St. Anthony Green Streets: 90% Design – Roadways

Resilience Design Review Committee
90% Design – Roadways

July 26, 2022

Major Comments from 90% Comments From DPW

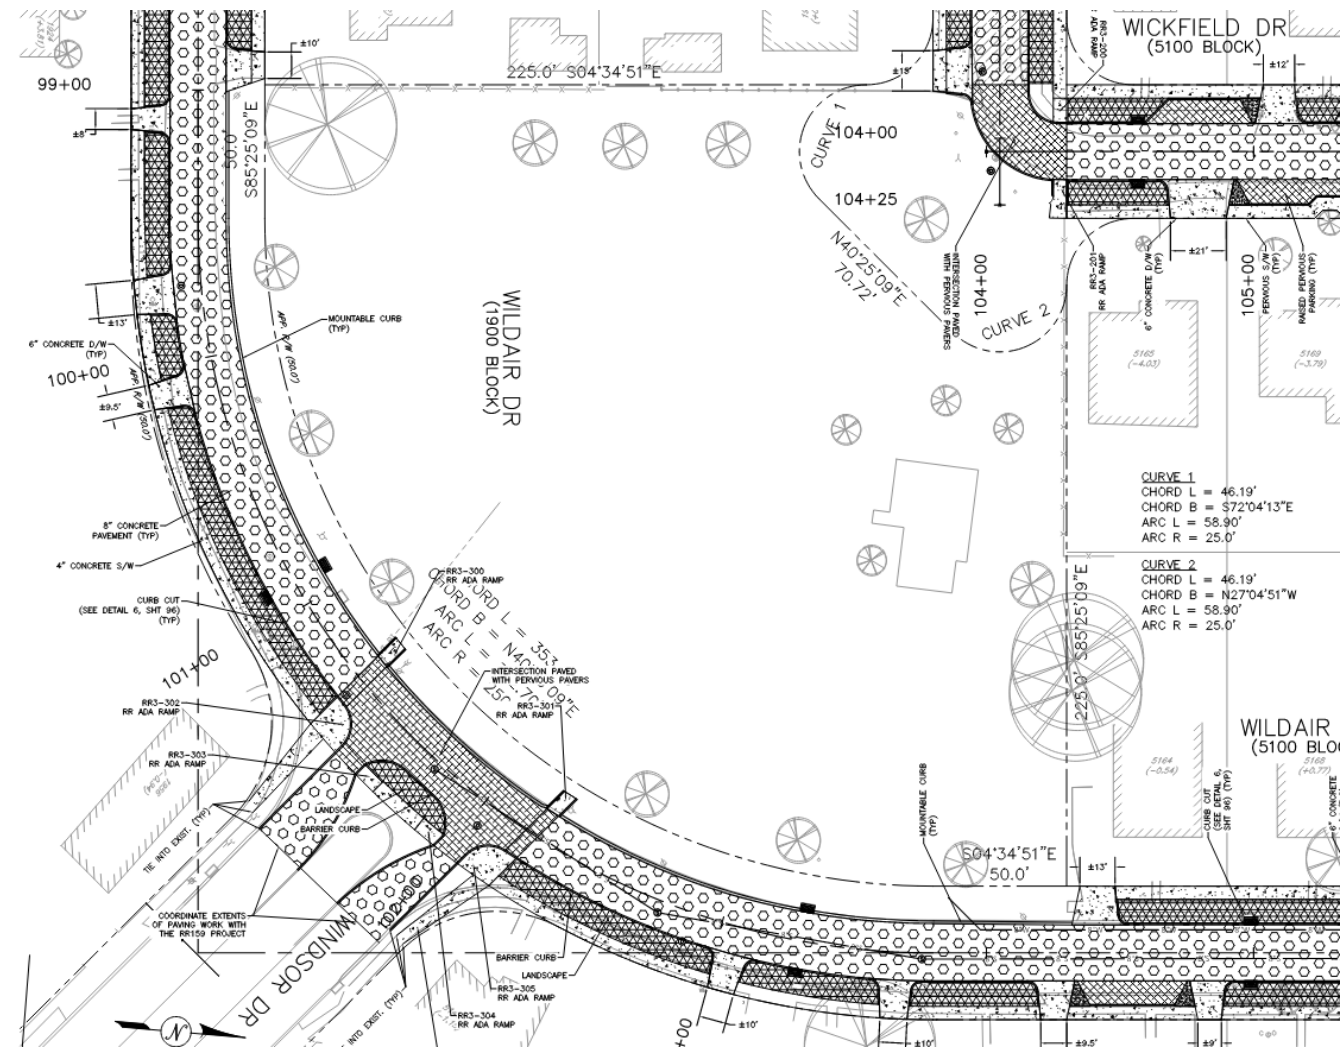
- The existing pavement of Wildair Dr. and Wickfield Dr. between Warrington Dr. and Filmore is asphalt therefore it should be replaced in kind.
 - Batture will update design to revise these blocks to asphalt as requested. Remaining blocks designed as concrete have either existing concrete or composite pavement, so replacement with concrete is justified.

- Relocation of sidewalks to the Property Line will cause additional saw cutting at driveways and sidewalks
 - This has been done to maximize space available for GI.

- In areas where there is no GI anticipated, back of sidewalks will be matched
- Concerns over use of Permeable Pavers in Intersections and crosswalks.

- Concerns over narrowing roadways widths of certain block from 26' to 22' to accommodate bioswales and permeable parking lanes. Major concern revolved around turning movements for fire trucks, garbage trucks, or other large vehicles.

- This design was done to not only provide additional drainage storage consistent with the objectives of the project, but also for the aesthetic purpose of continuing the neighborhood identity attempting to be portrayed throughout the project with these pavers being used in the parks and parking lanes.

- Manufacture Specs and examples of project will be shown that properly designed and constructed interlocking paver pavements can provide structural strength equal to or exceeding typical asphalt or concrete pavements.

- Batture is addressing this by creating vehicle turning movement simulations at intersections in question and will be presented to DPW.

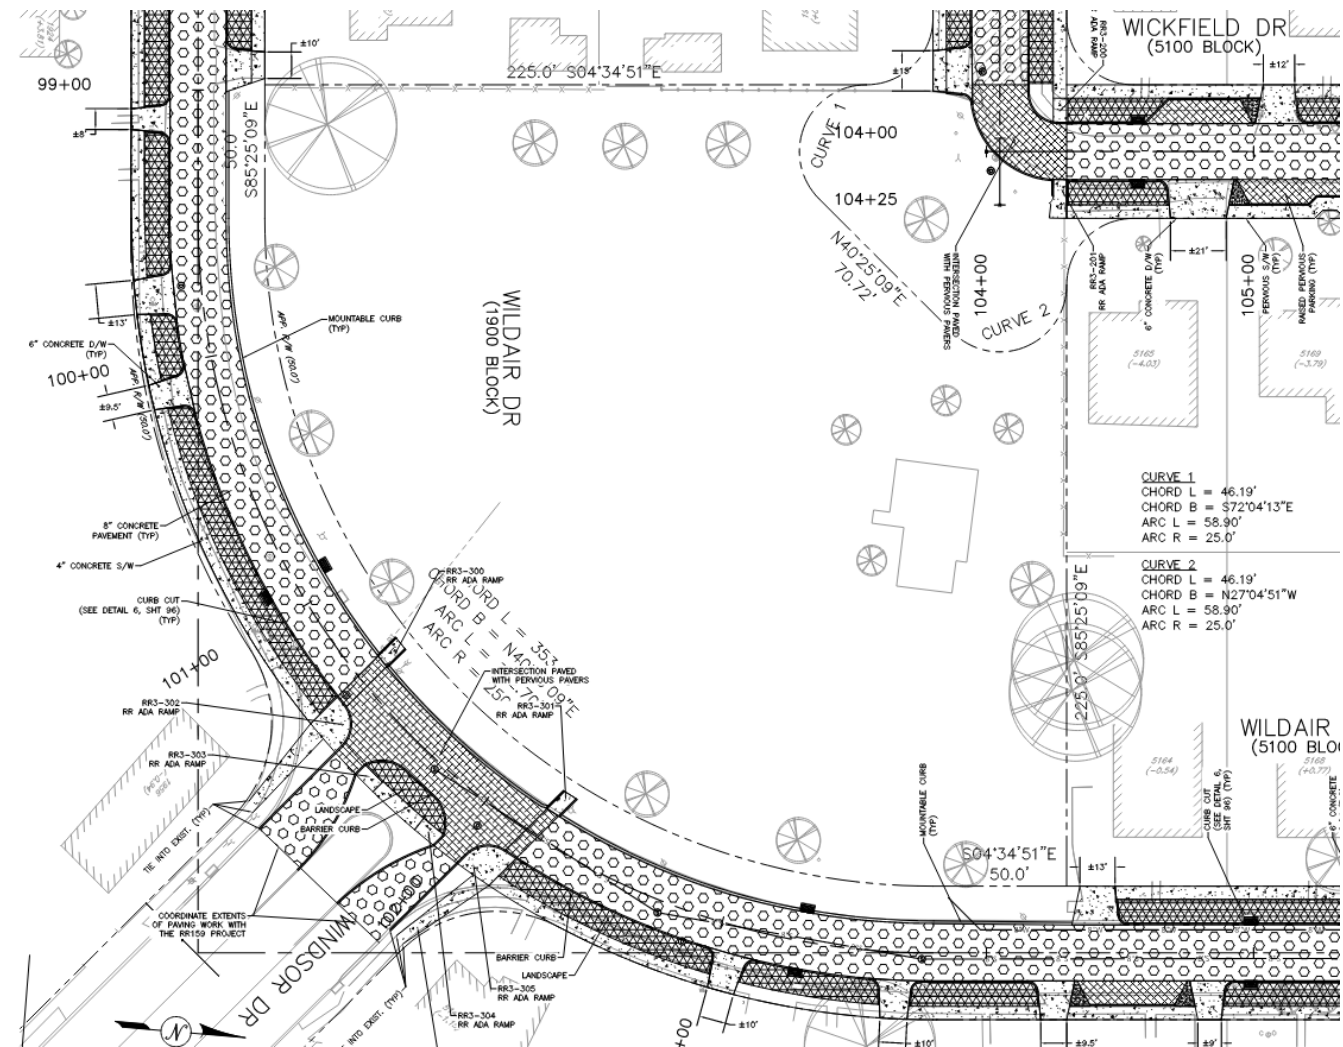
- The existing pavement of Wildair Dr. and Wickfield Dr. between Warrington Dr. and Filmore is asphalt therefore it should be replaced in kind.
 - Batture will update design to revise these block to asphalt as requested. Remaining blocks designed as concrete have either existing concrete or composite pavement, so replacement with concrete is justified.

- Relocation of sidewalks to the Property Line will cause additional saw cutting at driveways and sidewalks
 - This has been done to maximize space available for GI.

- In areas where there is no GI anticipated, back of sidewalks will be matched
- Concerns over use of Permeable Pavers in Intersections and crosswalks.

- Concerns over narrowing roadways widths of certain block from 26' to 22' to accommodate bioswales and permeable parking lanes. Major concern revolved around turning movements for fire trucks, garbage trucks, or other large vehicles.

- This design was done to not only provide additional drainage storage consistent with the objectives of the project, but also for the aesthetic purpose of continuing the neighborhood identity attempting to be portrayed throughout the project with these pavers being used in the parks and parking lanes.

- Manufacture Specs and examples of project will be shown that properly designed and constructed interlocking paver pavements can provide structural strength equal to or exceeding typical asphalt or concrete pavements.

- Batture is addressing this by creating vehicle turning movement simulations at intersections in question and will be presented to DPW.

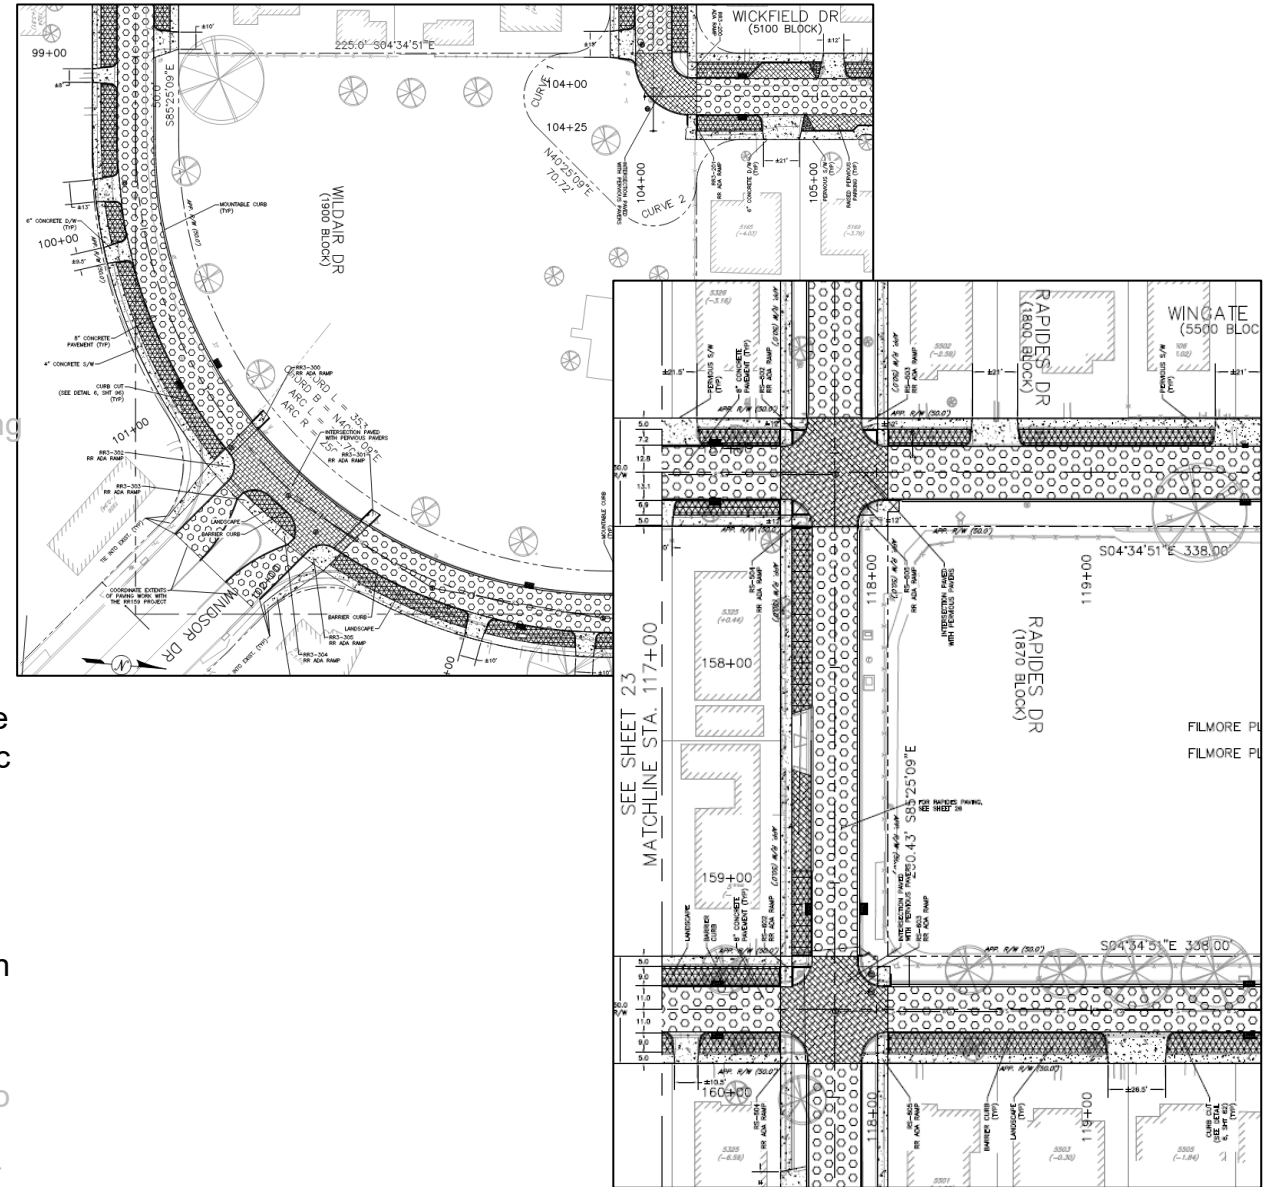
- The existing pavement of Wildair Dr. and Wickfield Dr. between Warrington Dr. and Filmore is asphalt therefore it should be replaced in kind.
 - Batture will update design to revise these block to asphalt as requested. Remaining blocks designed as concrete have either existing concrete or composite pavement, so replacement with concrete is justified.

- Relocation of sidewalks to the Property Line will cause additional saw cutting at driveways and sidewalks
 - This has been done to maximize space available for GI.

- In areas where there is no GI anticipated, back of sidewalks will be matched
- Concerns over use of Permeable Pavers in Intersections and crosswalks.

- Concerns over narrowing roadway widths of certain block from 26' to 22' to accommodate bioswales and permeable parking lanes. Major concern revolved around turning movements for fire trucks, garbage trucks, or other large vehicles.

- This design was done to not only provide additional drainage storage consistent with the objectives of the project, but also for the aesthetic purpose of continuing the neighborhood identity attempting to be portrayed throughout the project with these pavers being used in the parks and parking lanes.

- Manufacture Specs and examples of project will be shown that properly designed and constructed interlocking paver pavements can provide structural strength equal to or exceeding typical asphalt or concrete pavements.

- Batture is addressing this by creating vehicle turning movement simulations at intersections in question and will be presented to DPW.

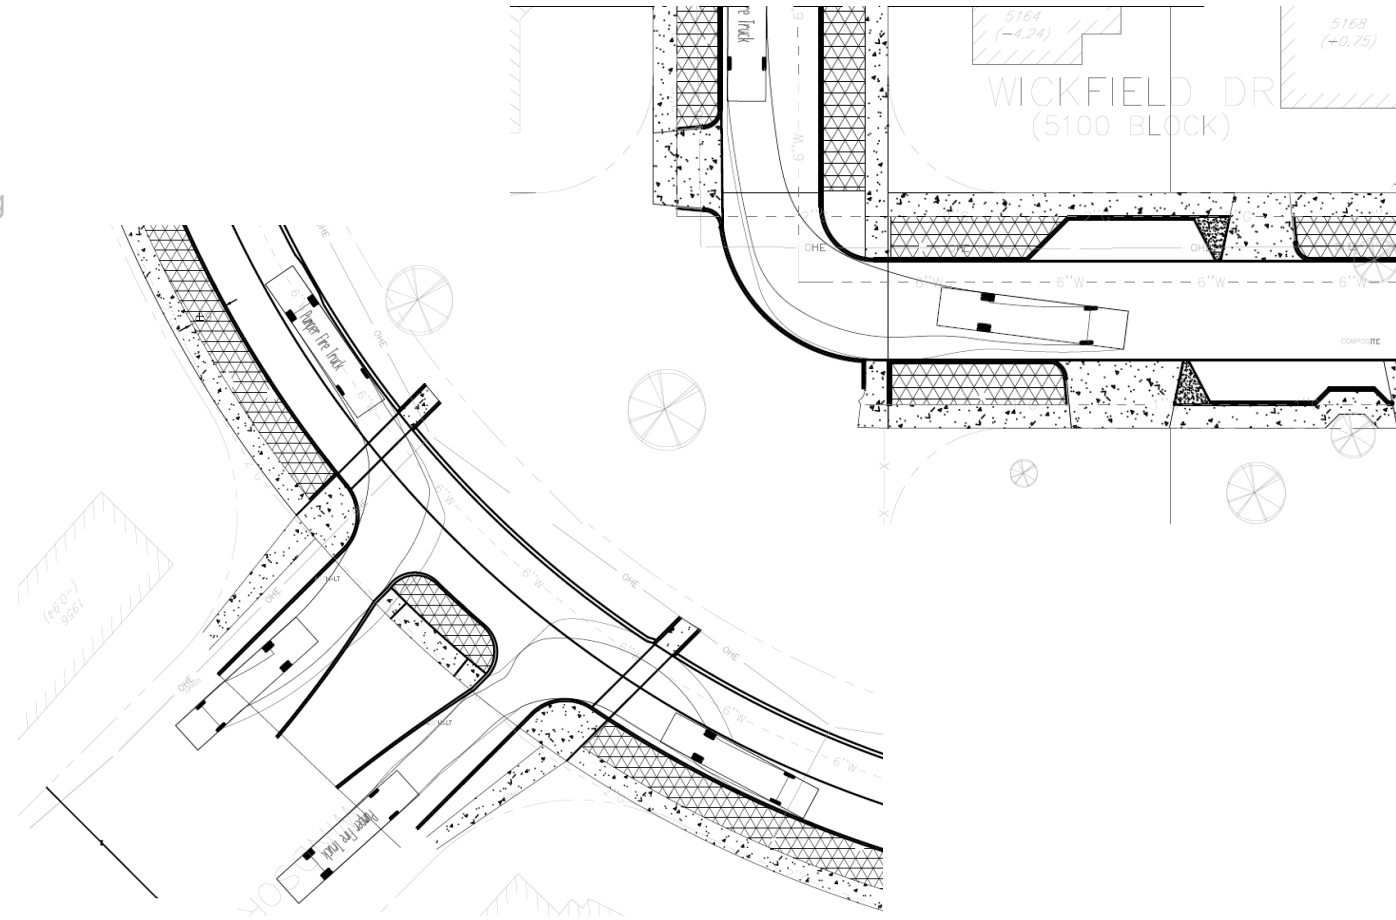
- The existing pavement of Wildair Dr. and Wickfield Dr. between Warrington Dr. and Filmore is asphalt therefore it should be replaced in kind.
 - Batture will update design to revise these block to asphalt as requested. Remaining blocks designed as concrete have either existing concrete or composite pavement, so replacement with concrete is justified.

- Relocation of sidewalks to the Property Line will cause additional saw cutting at driveways and sidewalks
 - This has been done to maximize space available for GI.

- In areas where there is no GI anticipated, back of sidewalks will be matched
- Concerns over use of Permeable Pavers in Intersections and crosswalks.

- Concerns over narrowing roadways widths of certain block from 26' to 22' to accommodate bioswales and permeable parking lanes. Major concern revolved around turning movements for fire trucks, garbage trucks, or other large vehicles.

- This design was done to not only provide additional drainage storage consistent with the objectives of the project, but also for the aesthetic purpose of continuing the neighborhood identity attempting to be portrayed throughout the project with these pavers being used in the parks and parking lanes.

- Manufacture Specs and examples of project will be shown that properly designed and constructed interlocking paver pavements can provide structural strength equal to or exceeding typical asphalt or concrete pavements.

- Batture is addressing this by creating vehicle turning movement simulations at intersections in question and will be presented to DPW.
